# Pentium<sup>®</sup> II Processor Specification Update

Release Date: March 1999

Order Number: 243337-024

The Pentium<sup>®</sup> II processor may contain design defects or errors known as errata which may cause the product to deviate from published specifications. Current characterized errata are documented in this Specification Update.

Figure 1. UP Dual Ended Termination (DET)

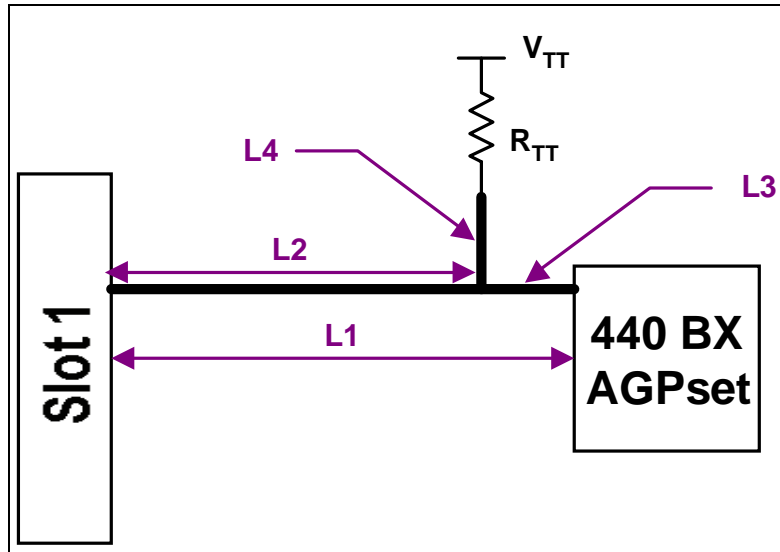
For UP-DET topologies (see Figure 1), the trace length  $L_1$  must be between 1.5" to 4.5" while using a 56 $\Omega$  termination resistor.

Figure 2. DP Dual Ended Termination (DET)

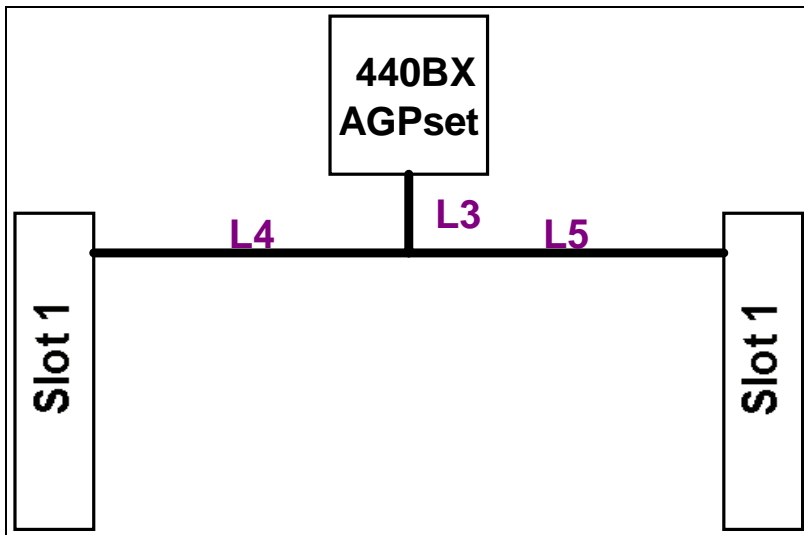
For DP topologies (see Figure 2) installed with a processor and a termination card,  $L4 + L3$  or  $L5 + L3$  must be less than or equal to 4.5". Additionally, for DP platforms with one processor installed, the termination card should be placed in the longer leg.

Figure 23. Processor with an Example Low Profile Heatsink Attached Using Spring Clips

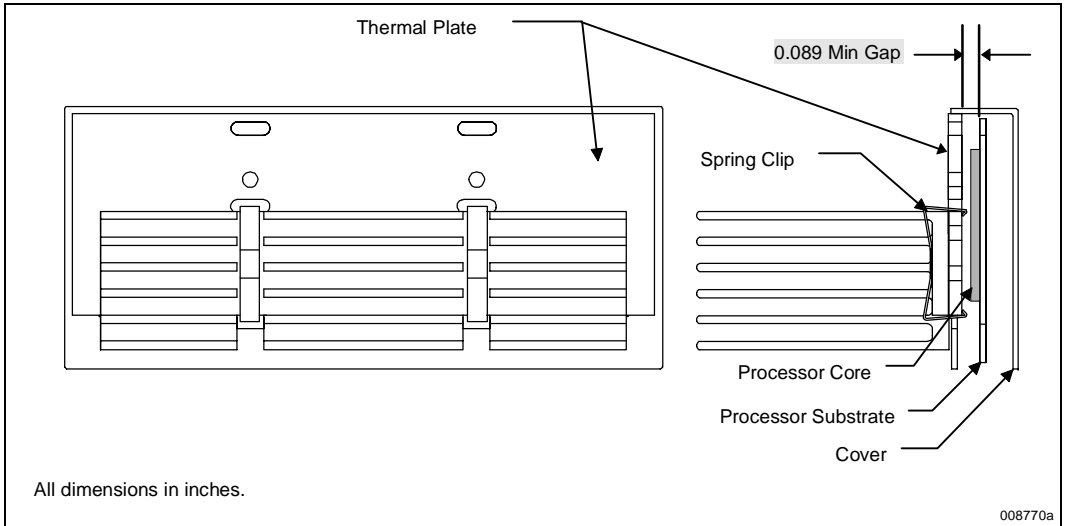
Figure 23 and Figure 24 illustrate example clip designs to support a low profile and a full height heatsink, respectively. The clips attach the heatsink by engaging with the underside of the thermal plate. The clearance of the thermal plate to the internal processor substrate is a minimum **0.089"** (illustrated in Figure 23 and Figure 24). The clips should be designed such that they will engage within this space, and also not damage the substrate upon insertion or removal. Finally, the clips should be able to retain the heatsink onto the thermal plate through a system level mechanical shock and vibration test. The clips should also apply a high enough force to spread the interface material for the spot size selected.

Figure 26. Heatsink Rivscrew\* and Thermal Plate Recommendations and Guidelines

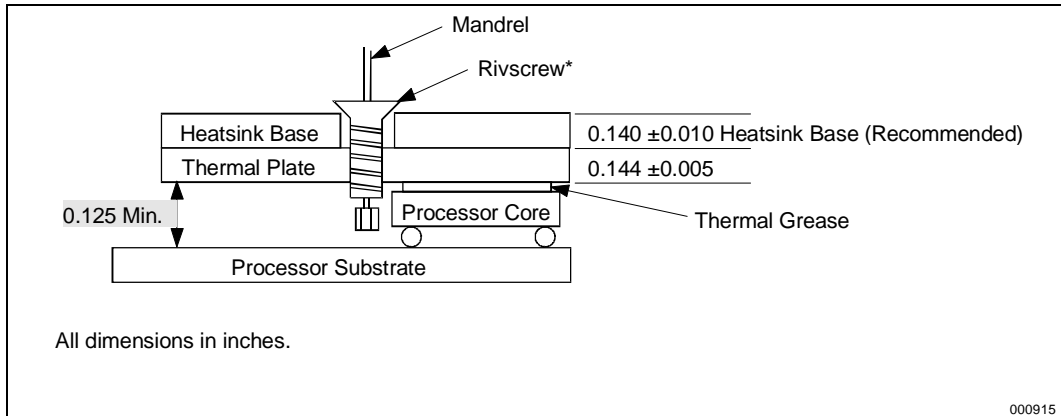
The Rivscrew attach mechanism uses a specialized rivet that is inserted through a hole in the heatsink into the thermal plate. Upon insertion, a threaded fastener is formed that can be removed if necessary. For Rivscrew attachment, the minimum gap between the thermal plate and the processor substrate is **0.125"**. For use of the Advell Rivscrew (part number 1712-3510), the heatsink base thickness must be  $0.140 \pm 0.010"$ . See Figure 25, Figure 26 and Figure 27 for details of heatsink requirements for use with Rivscrews.

**Figure 6. BCLK to Core Logic Offset**

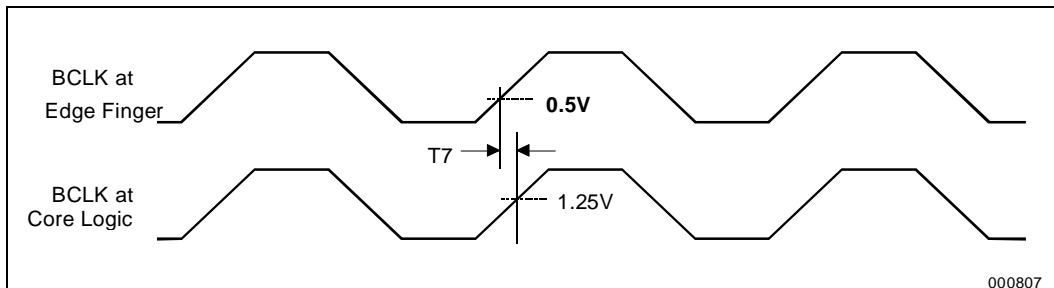
In Figure 6 of the *Pentium® II Processor at 233 MHz, 266 MHz, 300 MHz, and 333 MHz* datasheet, the following changes should be made:

Figure 7. BCLK\*, PICCLK, and TCK Generic Clock Waveform

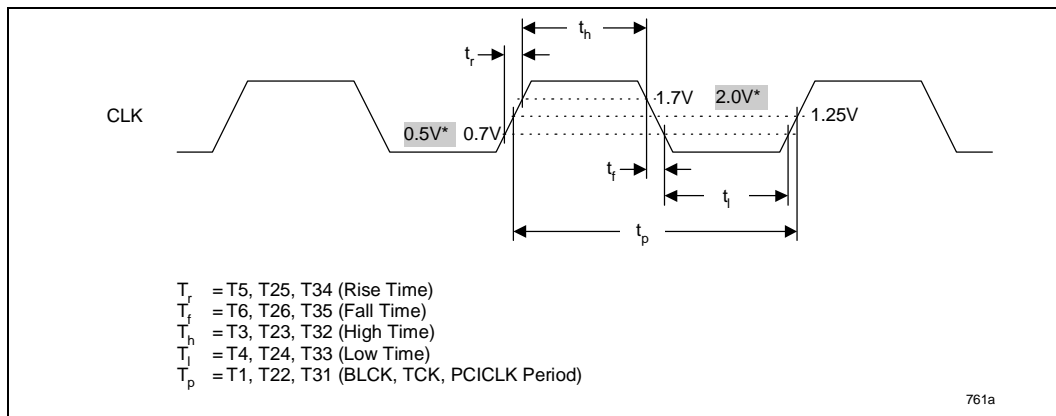
In Figure 7 of the *Pentium® II Processor at 233 MHz, 266 MHz, 300 MHz, and 333 MHz* datasheet, the following changes should be made:
